CCPS RFP#24-15 – NORTH EAST MIDDLE/HIGH SCHOOL REPLACEMENT PROJECT

ADDENDUM #03

This addendum is to address Bid RFIS, contract drawings, and specification modifications as noted below. Proposers and related parties will be responsible for reading and understanding all documents, the scope of work, addenda and all related solicitation documents issued. These documents will become attached to and part of the solicitation and award of bid contract.

ITEM No. 4 **CONTRACT DRAWINGS AND SPECIFICATIONS – Changes and clarifications dated 03/25/2024**

A307

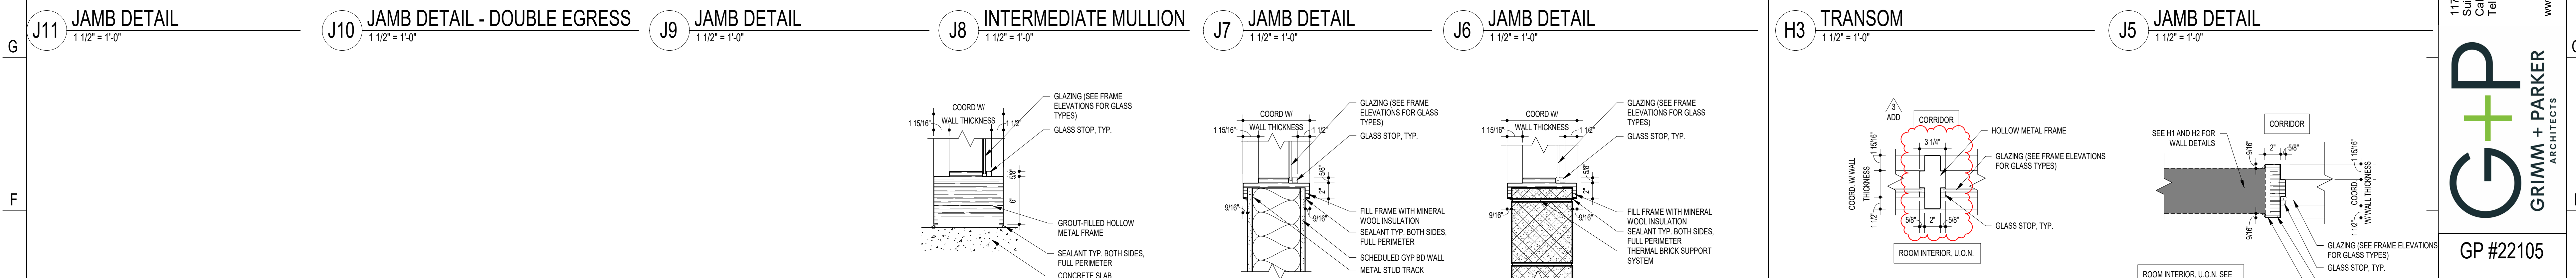
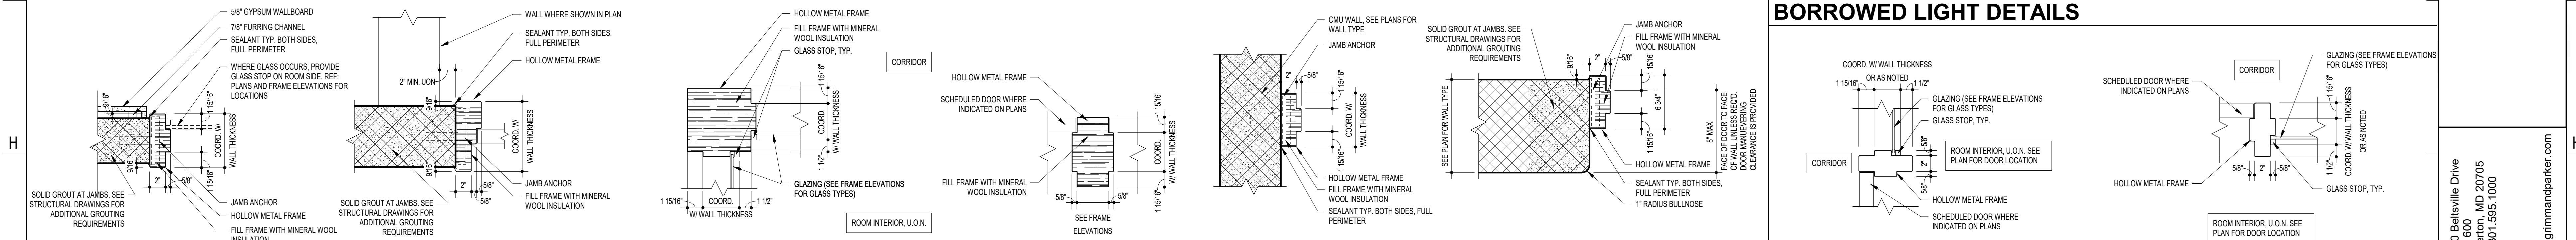
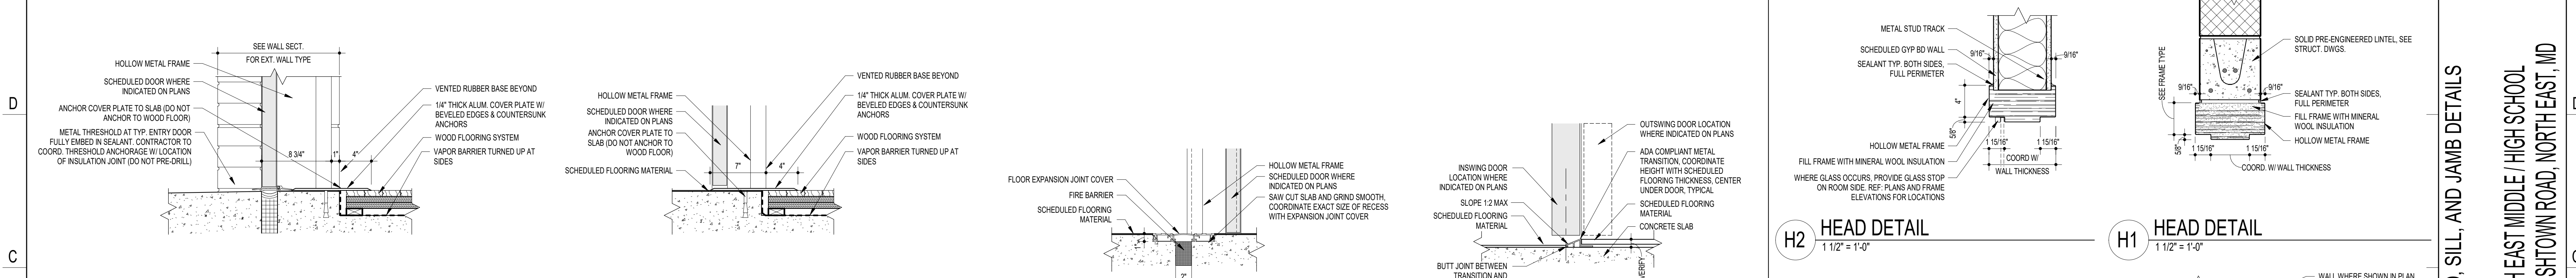
Revise sheet A307 per attached reissued sheet:

MILLWORK AND INTERIOR DETAILS - TYPICALS
NORTH EAST MIDDLE / HIGH SCHOOL
300 IRISTOWN ROAD, NORTH EAST, MD

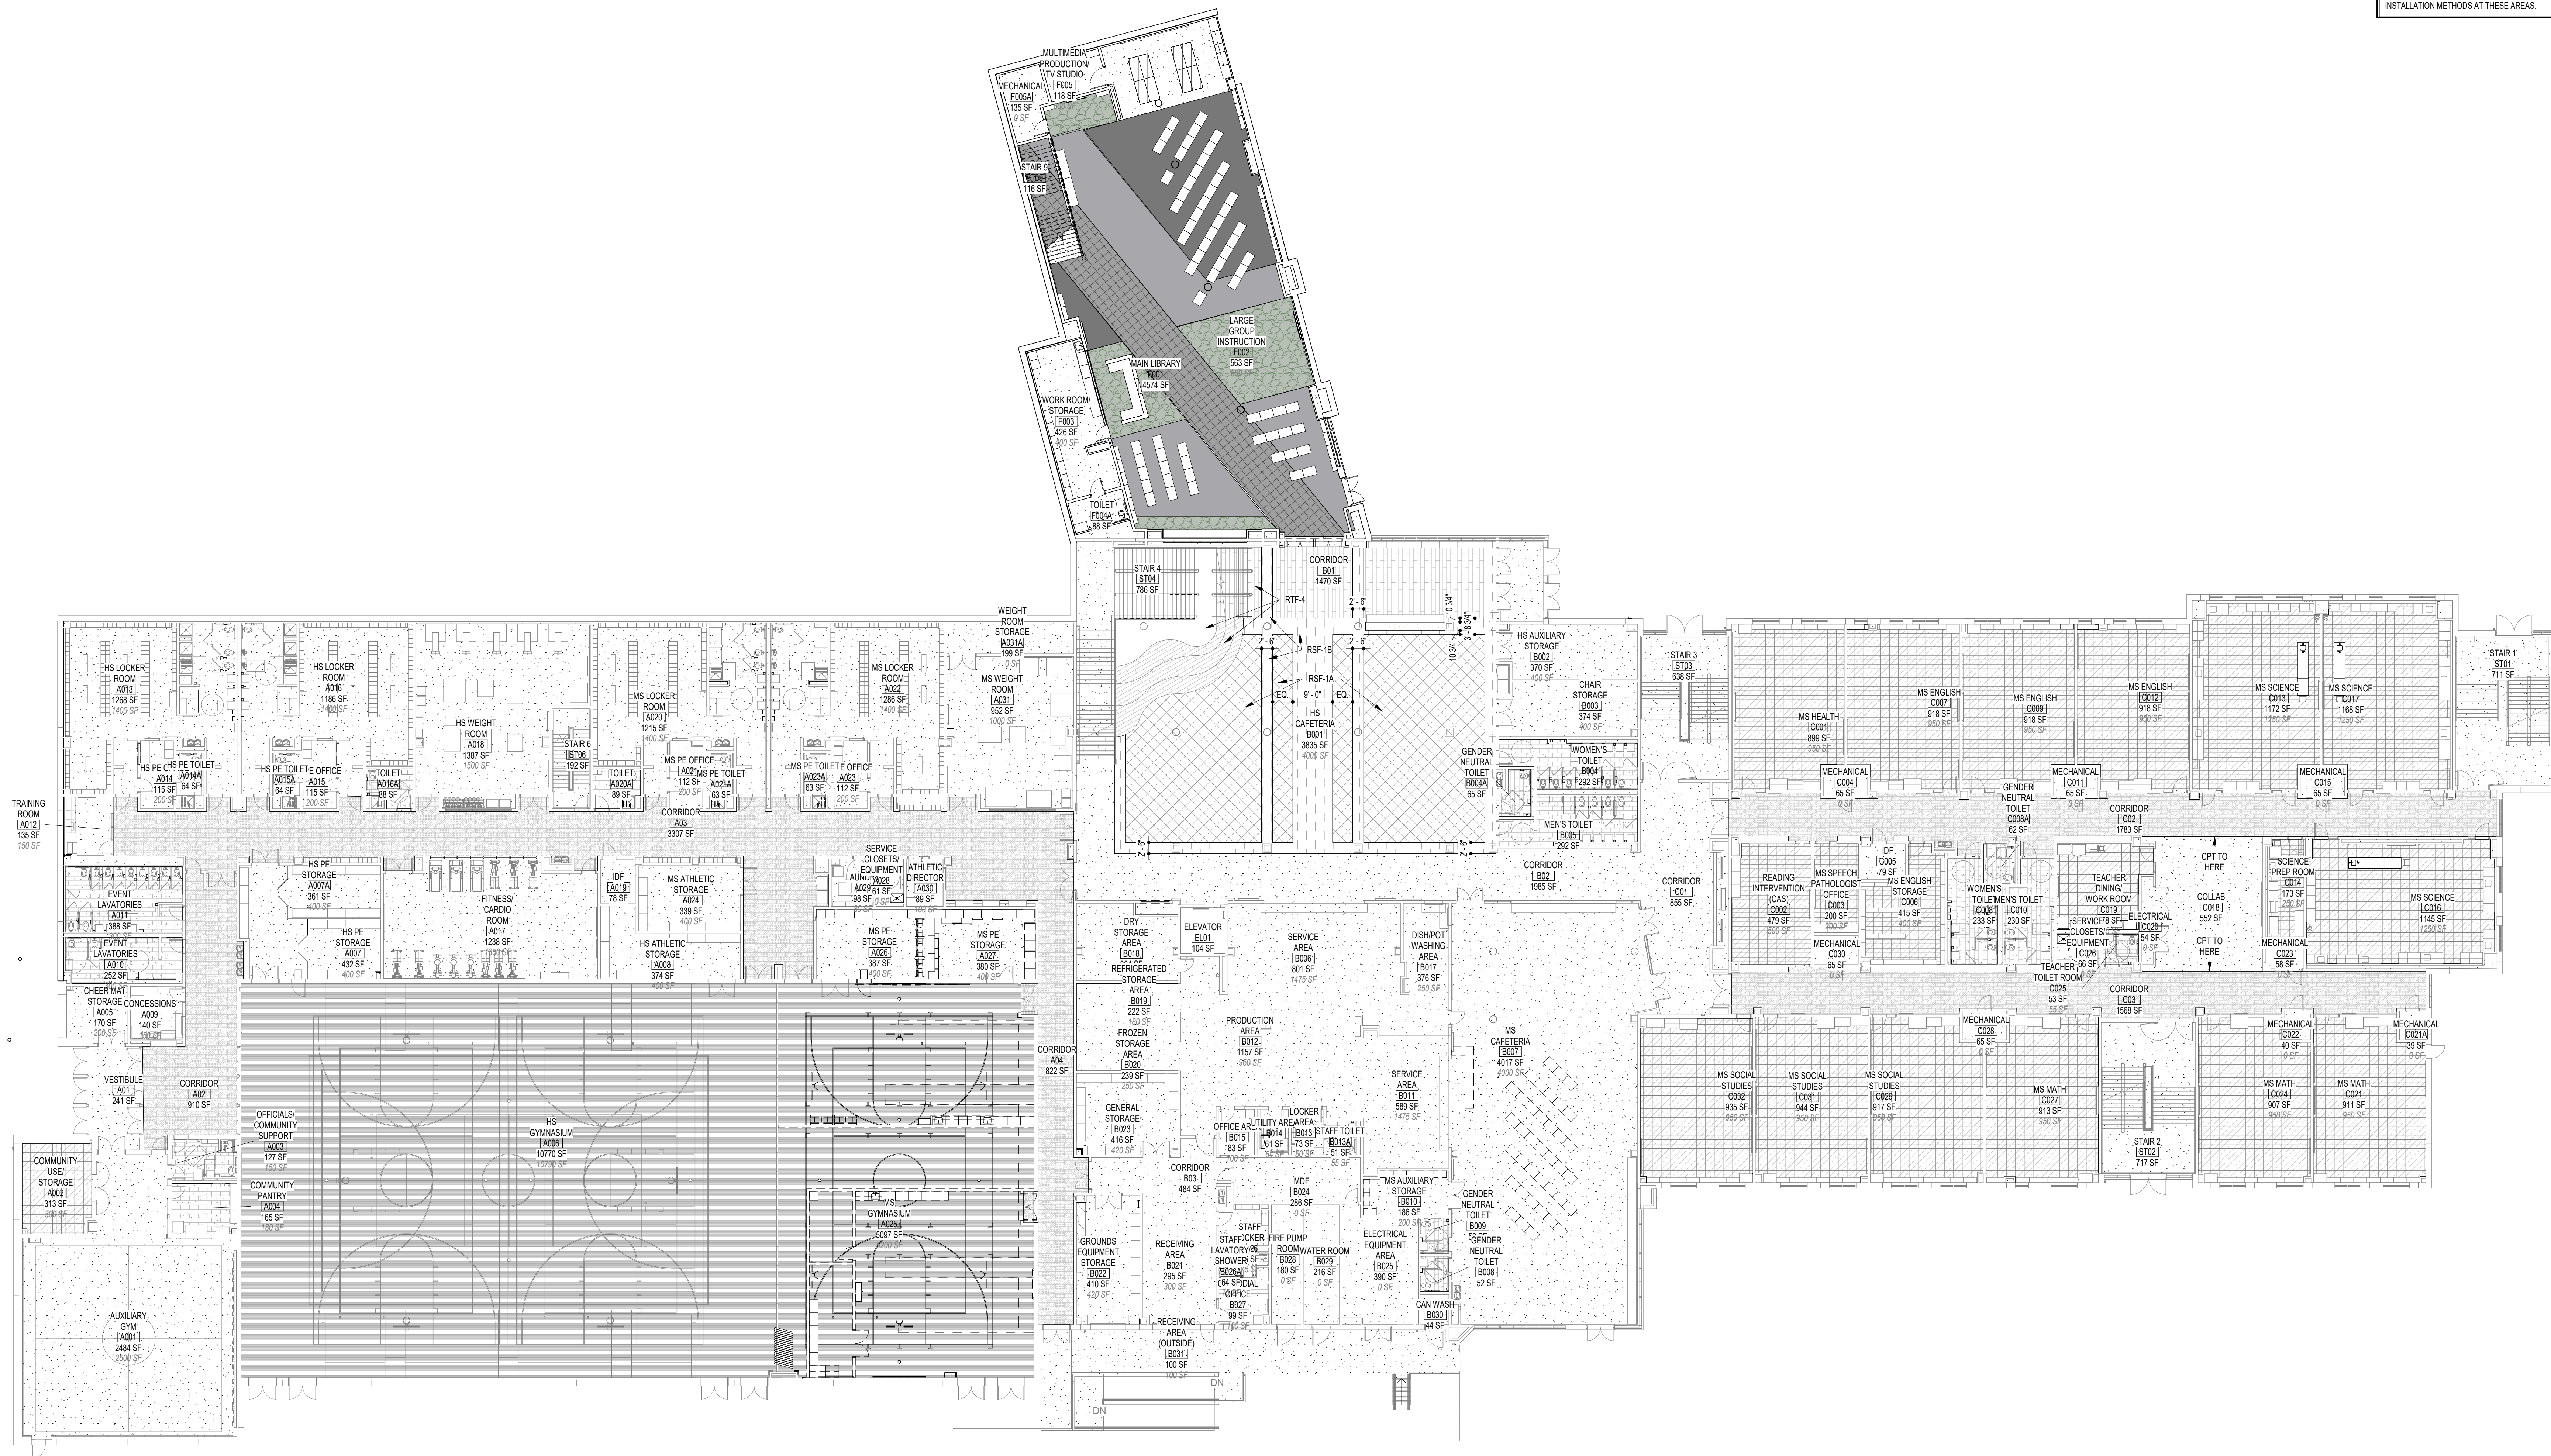
Revise sheet A804 per attached reissued sheet:

REVISE Delete Detail D10.

REVISE Countertop profile on Detail D7.
